# Access Compliance Report

## Public Rights-of-Way

| Intersection ID: 10136                  | Main Street: BURKHOLDER_RD | Cross Street: SHEETS_CR                 | Location:              | N/A                   |
| ADA ID: DFD4A11703A1                    | Ramp Type: Perp            | Initial Pass/Fail: Fail                 | Overall Compliance: No | Severity Score: 33.75 |

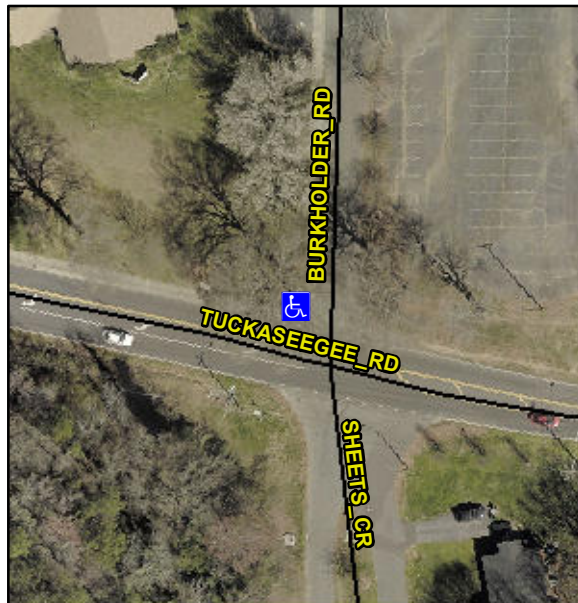
**Not Found, R304.5.1, R304.5.3**

| Compliance | Description           | Data | Compliance | Description                 | Data |
|------------|-----------------------|------|------------|-----------------------------|------|
| No         | Ramp Width (in)       | 46.0 | No         | Ramp XSlope (%)             | 7.8  |

**Remove & Replace Entire Ramp.**
